EXXON GETTYSBURG

The EXXON GETTYSBURG is expected to enter Newport News Shipyard in May to undergo repairs and alterations. We request that you prepare necessary engineering designs for: (I) conversion of the aft potable water tank and all applicable piping in the amidship square to a sewage holding system, (II) installation of a FAST treatment system and alteration of sanitary piping in the after house, and (III) modification of the cargo manifold. This work will be included in specifications sent at a later time by our repair department, but is being sent in advance to allow time for engineering designs to be developed and approvals processed.

EXXON GETTYSBURG - 1978 SHIPYARD SPECIFICATIONS

STARBOARD CARGO MANIFOLD - MODIFICATION

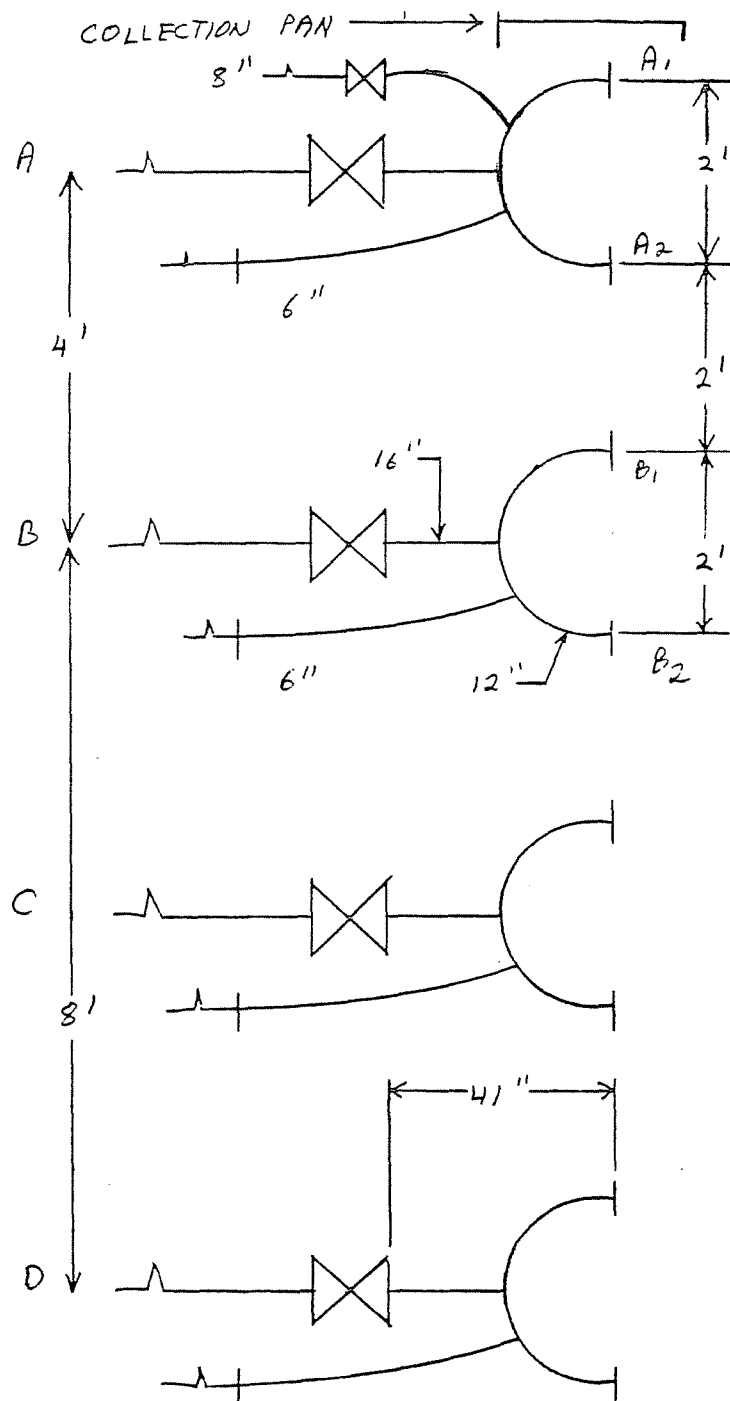
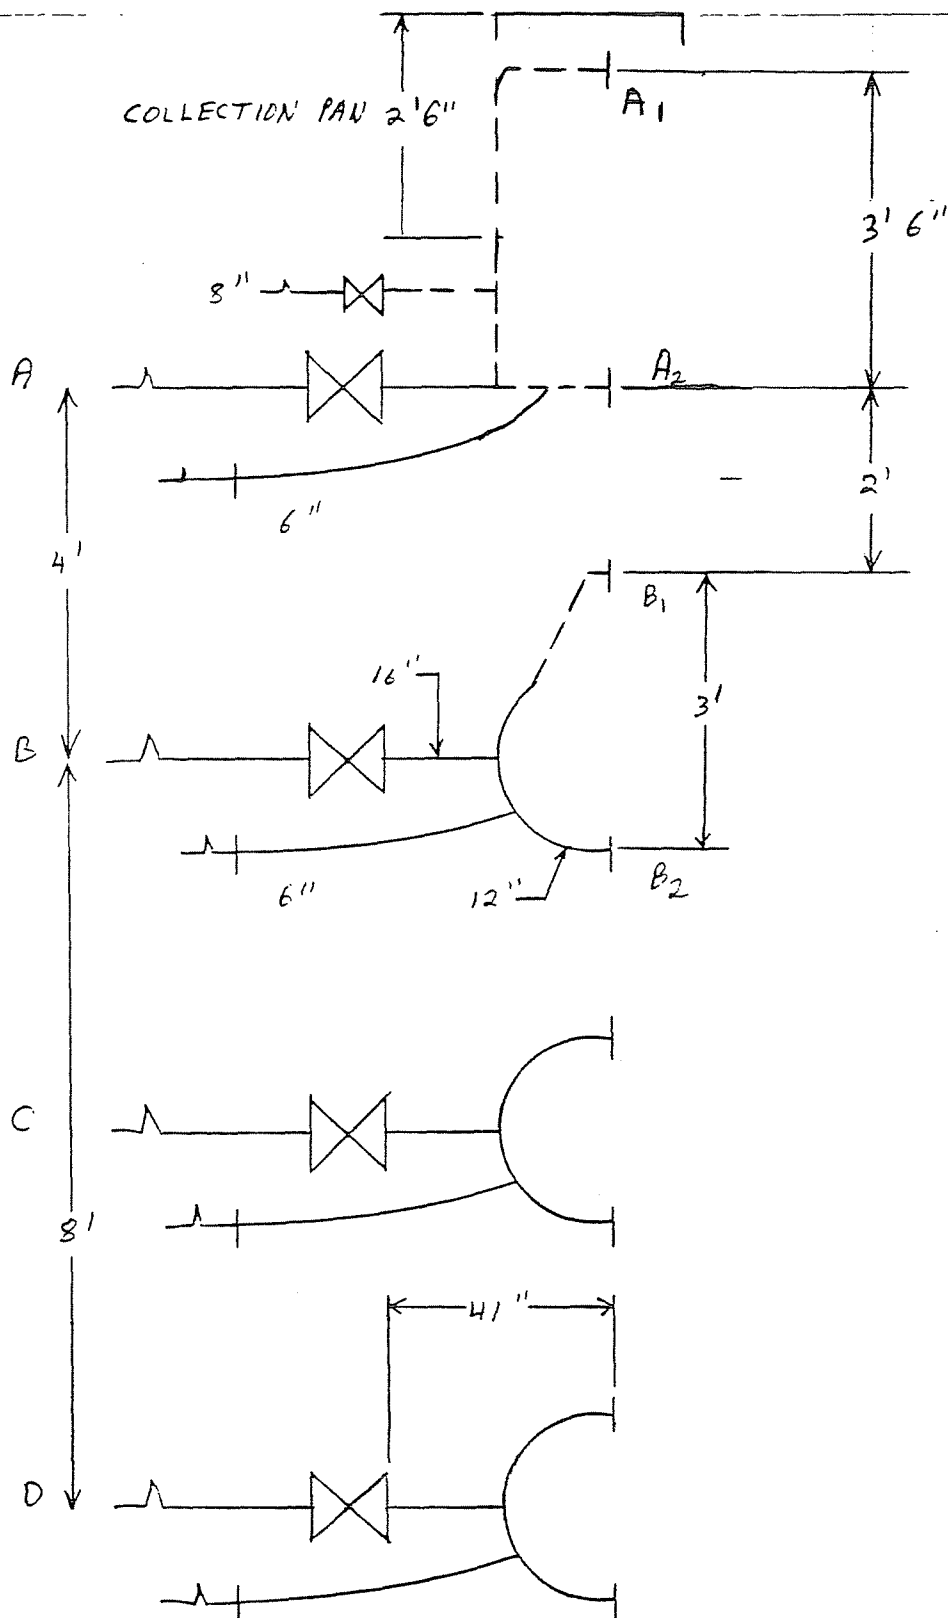
Provide labor and material to modify the port and starboard cargo manifolds in accordance with the attached sketches. Only lines A and B are to be altered. Spacing is to be as follows:

A ₁ to A ₂	3'6"
A ₂ to B ₁	2'
B ₁ to B ₂	3'
B ₂ to C ₁	2' (as existing)

Remove the existing four (4) cargo line Y-connections (A and B port and A and B starboard), and furnish and install four (4) new cargo line Y-connections. Remove the existing spool reduction pieces from the A and B lines (8 spools total), and install them in the same sequence on the new Y-connections. Each new Y is to be properly supported and tied to the existing stripper line(s). A centrally located 1-1/2" drain line and ball valve are to be furnished and installed with each new Y. The drain line is to allow drainage from the cargo line to the collection pan.

Furnish and install a 2-1/2' extension to the forward side of the existing drip pan, port and starboard. Support as needed.
